ADDENDUM NO. 1

Reference: New Cedar City Liquor and Wine Store
Department of Alcoholic Beverage Control
DFCM Project No. 08227030

Addendum No. A01

PROJECT
New Cedar City, UT Liquor Store
Department of Alcoholic Beverage Control
Cedar City, Utah
DFCM Project No. 08227030

LOCKER ROOM BENCH

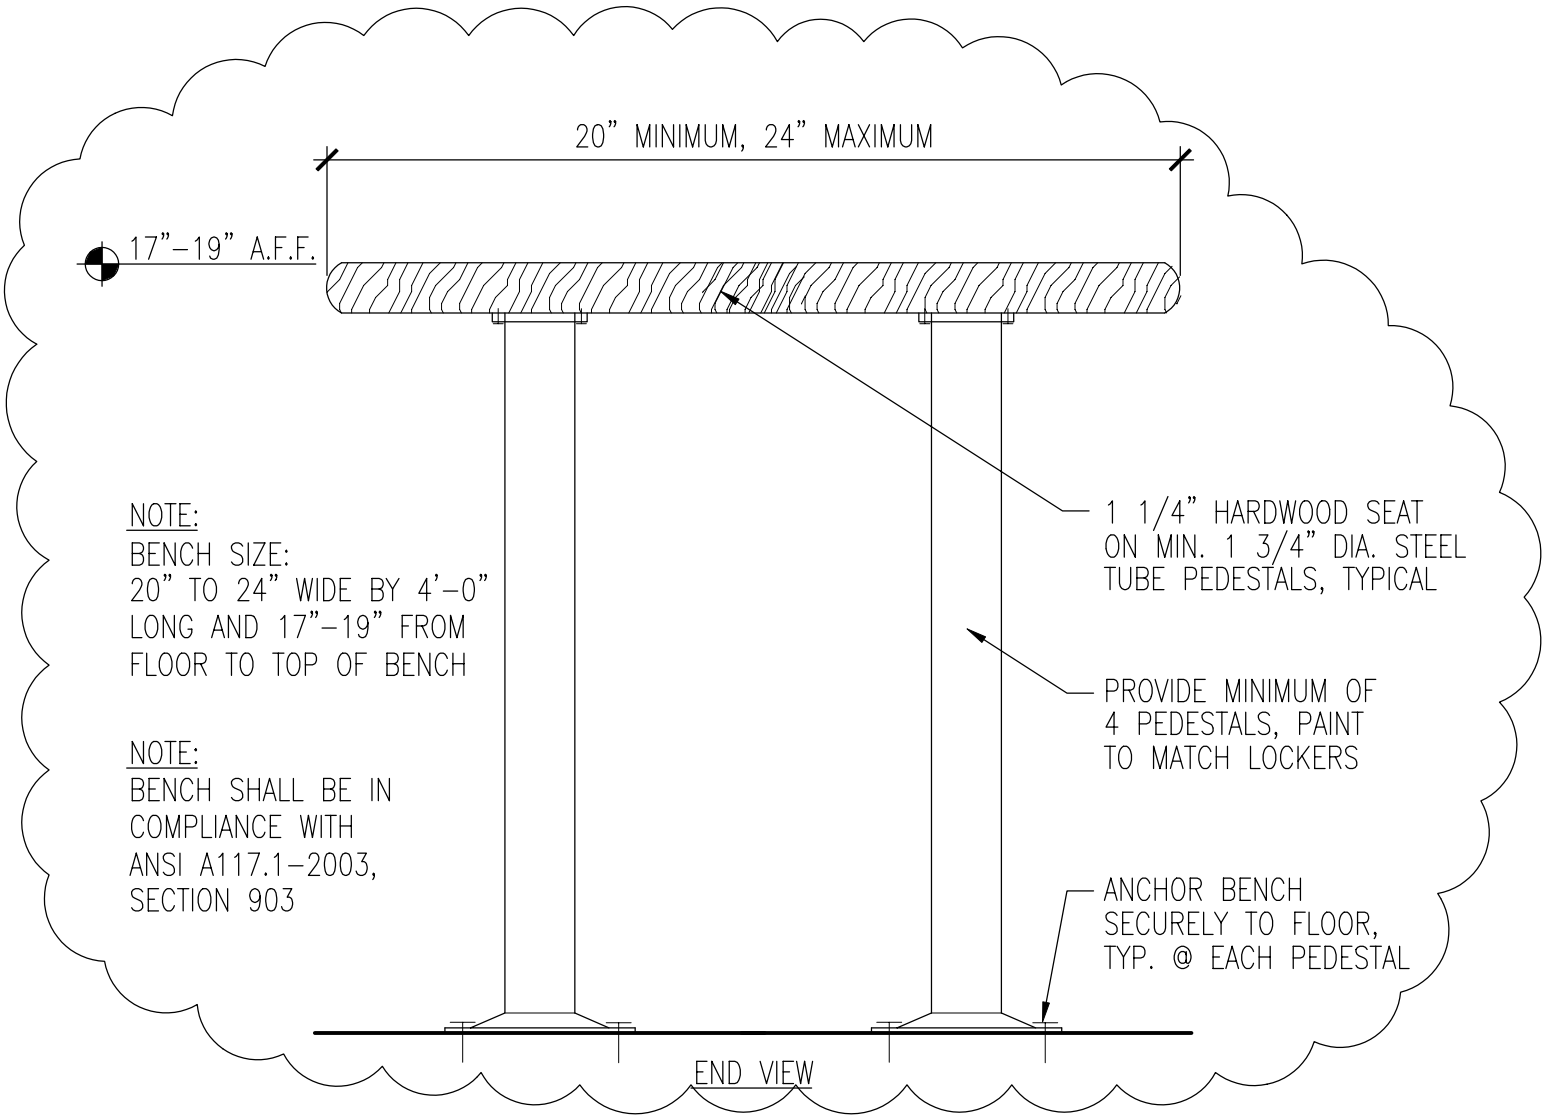
1. **Sheet A104:**
   a. Revised Detail 11/A104, referencing the bench. Refer to **new drawing ADD-01**.
   b. Revised Detail 17/A104, referencing the bench. Refer to **new drawing ADD-02**.
   c. Revised Detail 19/A104. The height of the handrail above the nosing of the steps is 2'-8" from the nosing to the top of the handrail and the railing extensions at the top and bottom of the stairs shall be 2'-8" from the floor surface to the top of the handrail. This detail also references the bench. Refer to **new drawing ADD-03**.
   d. Revised Detail 20/A104, referencing the bench. Refer to **new drawing Add-04**.

FIGURE 2
VICINITY MAP/ SITE PLAN

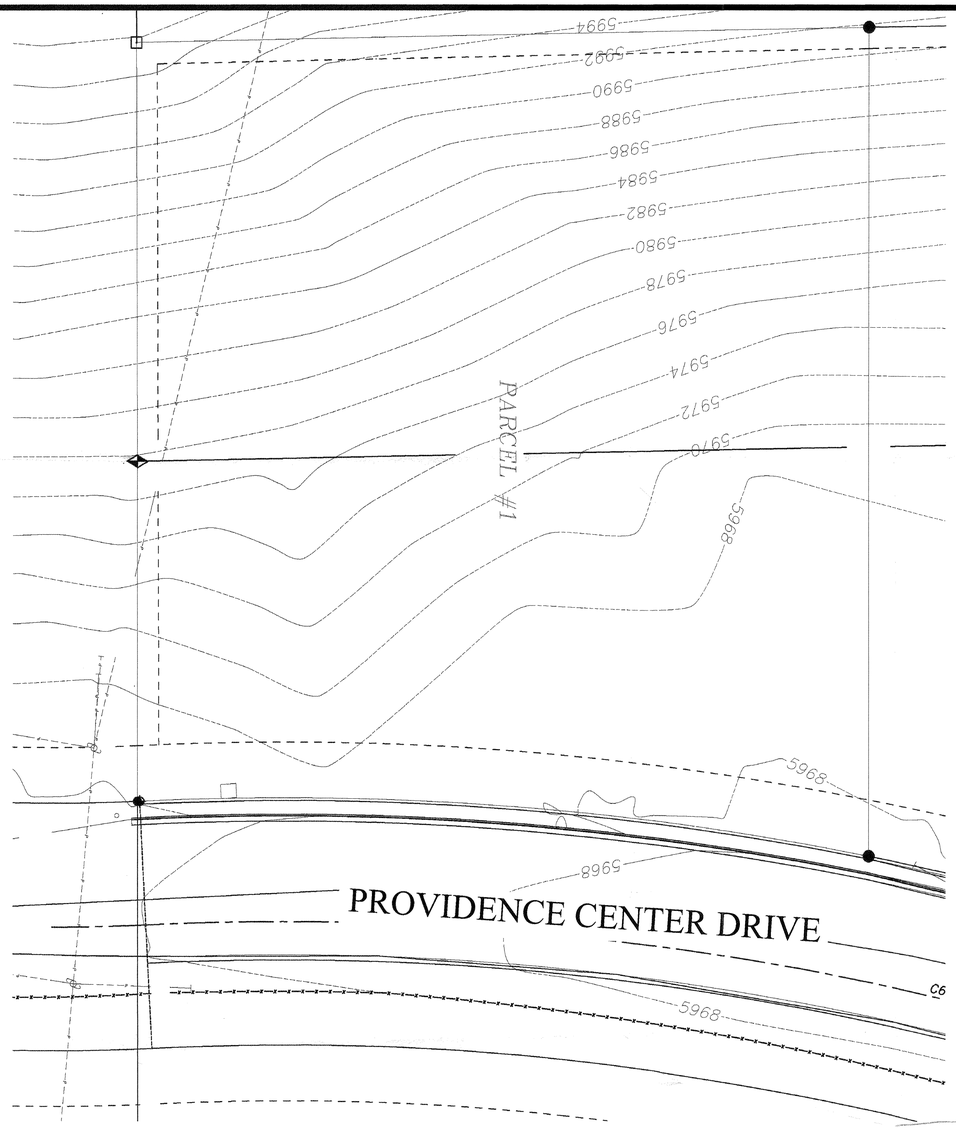
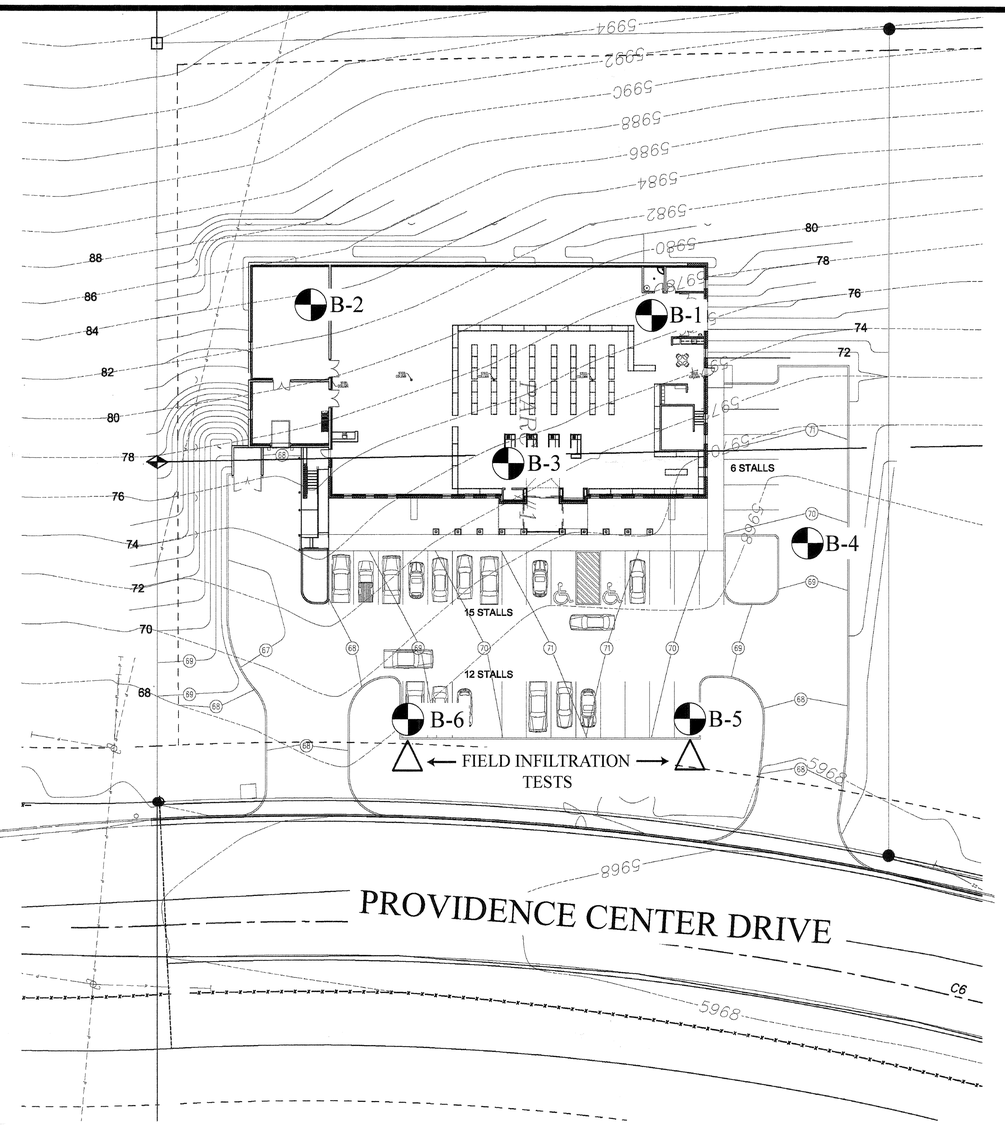
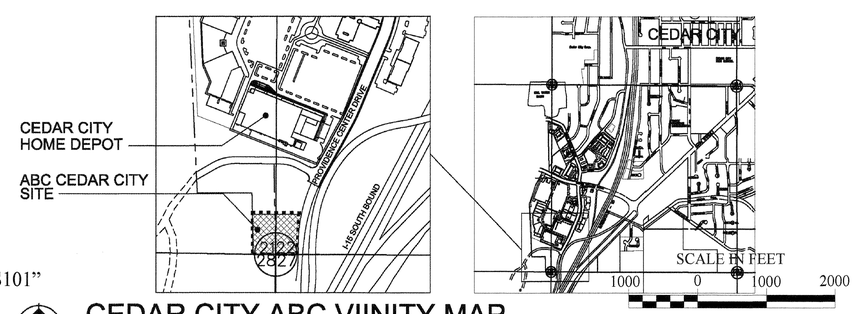
1. **Appendix A-1 Subsurface Investigation:**
   a. Figure 2 Drawing – Vicinity Map/Site Drawing showing the boring locations is included as part of this addendum.
2. **Specification Section 10500** – PART 2 PRODUCTS, 2.3 BENCH MATERIALS, add the following:
